Office of Bridges & Structures
FHWA-HIF-19-007

Hydraulic Considerations for Shallow Abutment Foundations

Errata Sheet

December 15, 2020 – version 1.1

Figure 9: Free-Surface Flow, Narrow-Opening Scour Countermeasure.

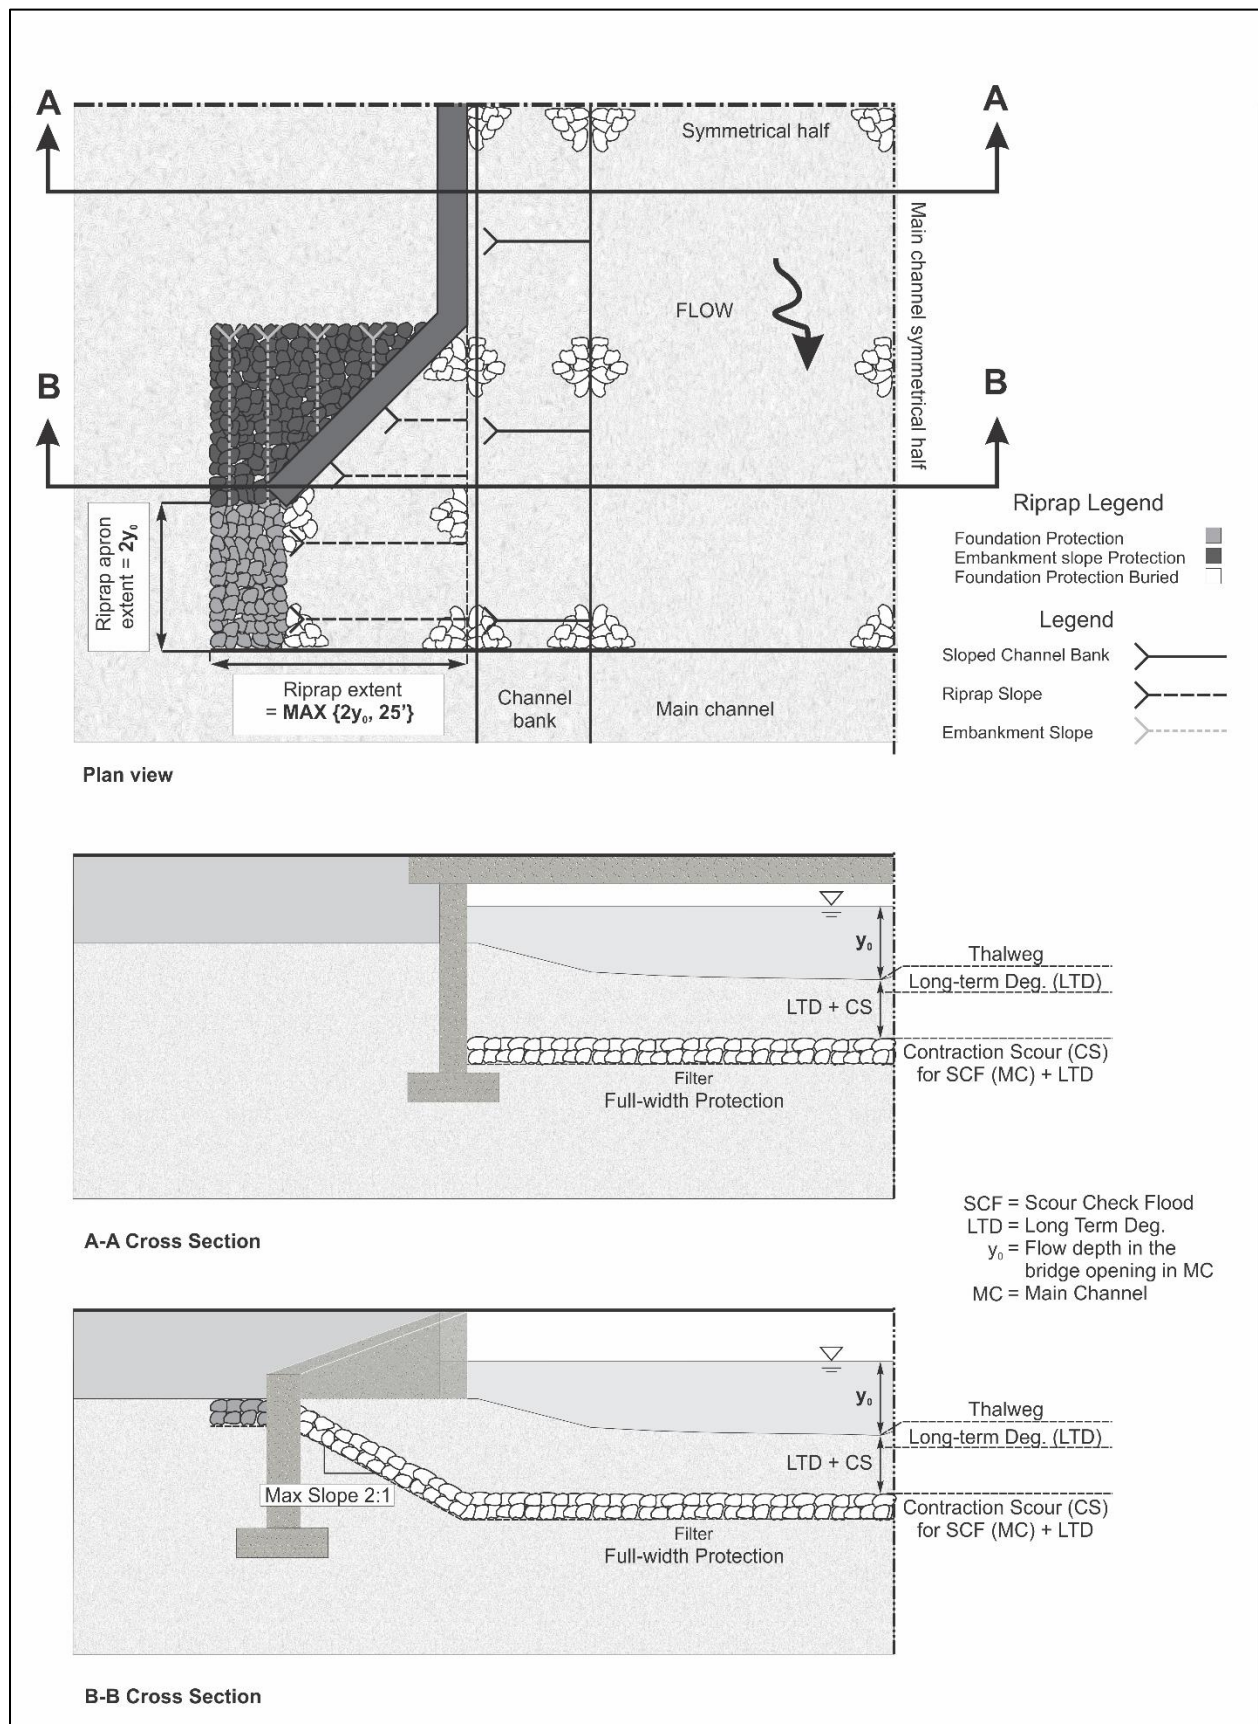
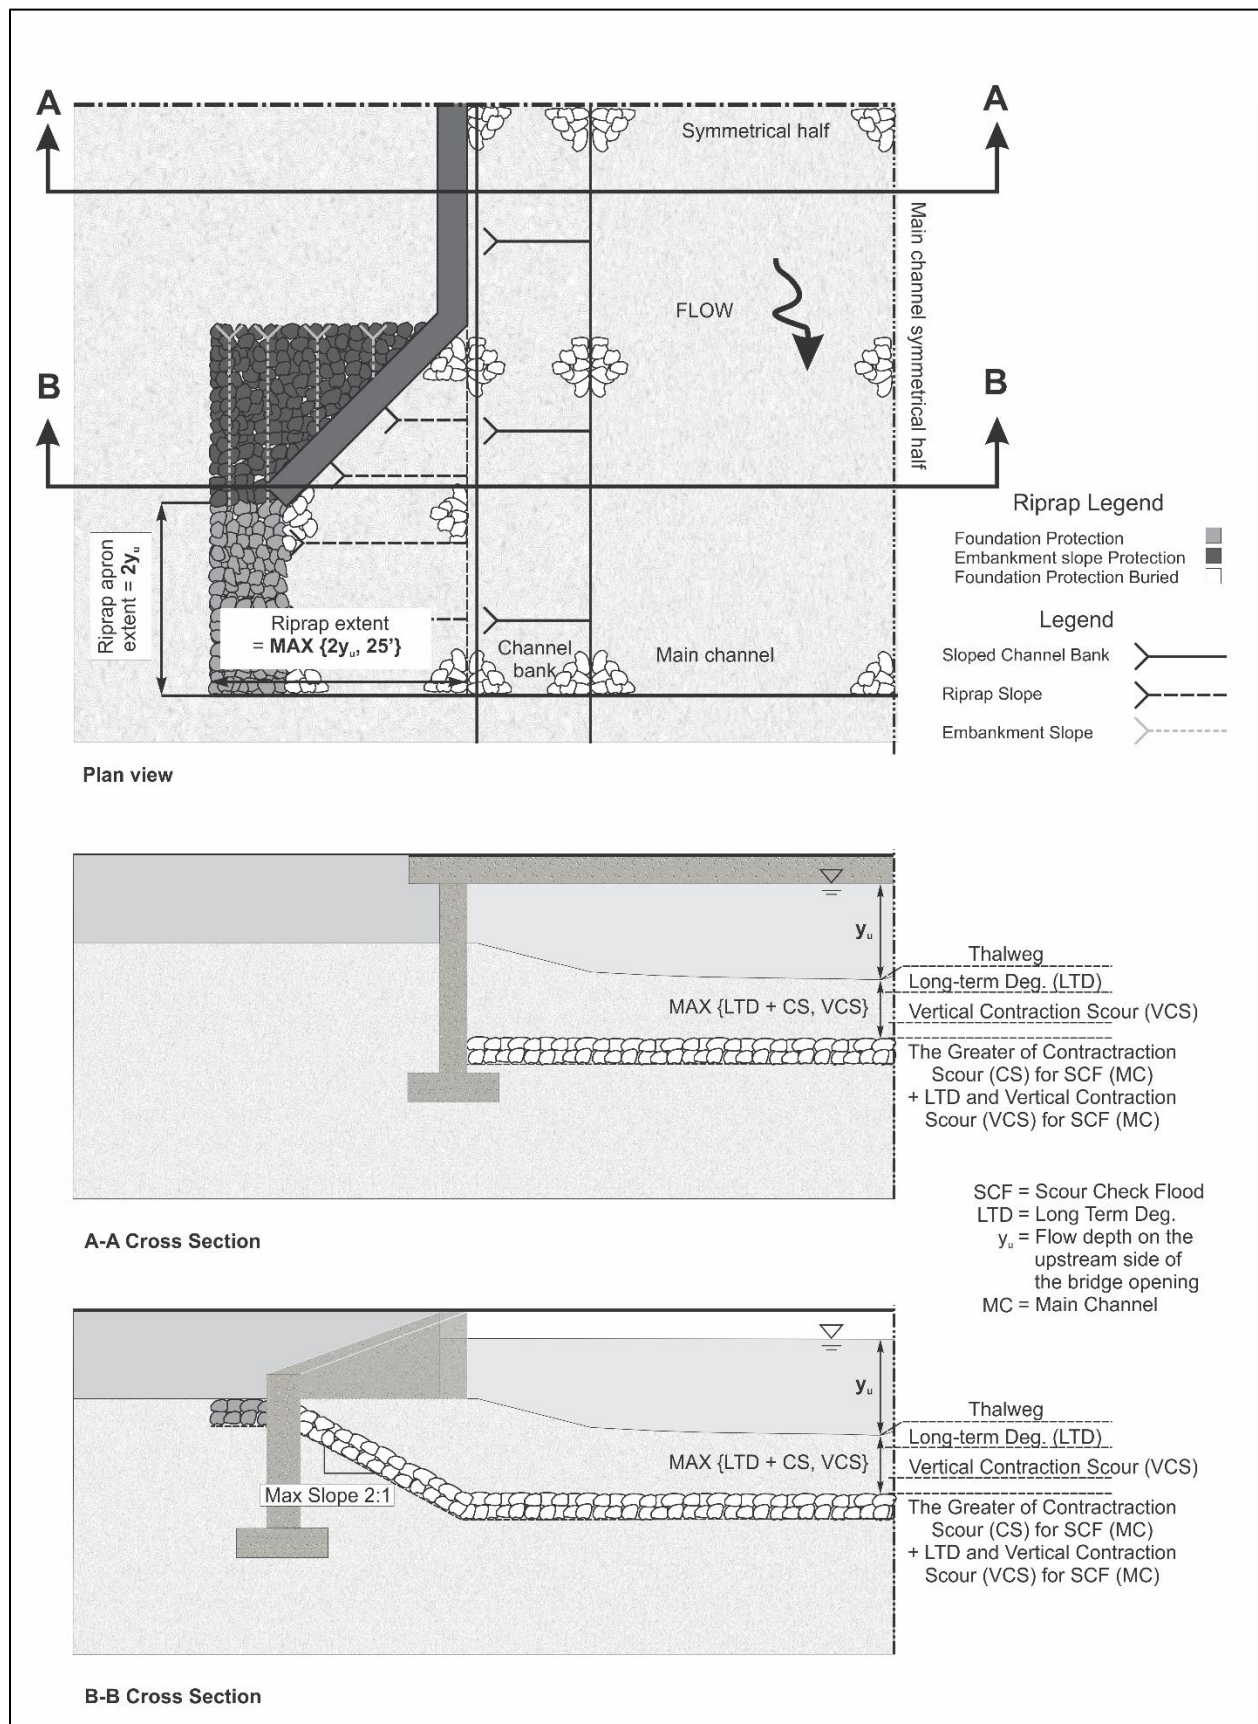
9	7	Language in F) 1. and 2.	<p>Revised to “<i>...(includes any long-term degradation where main-channel hydraulics apply)...</i>”</p> <p>This clarified the distinction of scour considerations for abutments that are near the main channel versus those that are sufficiently set back from the channel.</p>
10	9	Free-Surface Flow 3.a.	<p>Replaced “<i>(either clear-water or live-bed)</i>” with, “<i>(Scour Condition A or B)</i>”.</p> <p>This clarified the use of the NCHRP 24-20 abutment scour conditions.</p>
11	10	Language in Free Surface Flow numbers 2, 3, 4 and Pressure Flow number 1	<p>Revised “<i>Top of footing below countermeasure</i>” to say “<i>Top of footing below countermeasure apron</i>”</p> <p>This clarified the footing placement relative to the countermeasure apron elevation.</p>
12	14	Figure 7, shallow foundation elevation	Revised Figure 7 to lower the shallow abutment foundation to clearly depict that the top of the foundation is below the CS for SCF (MC) + LTD
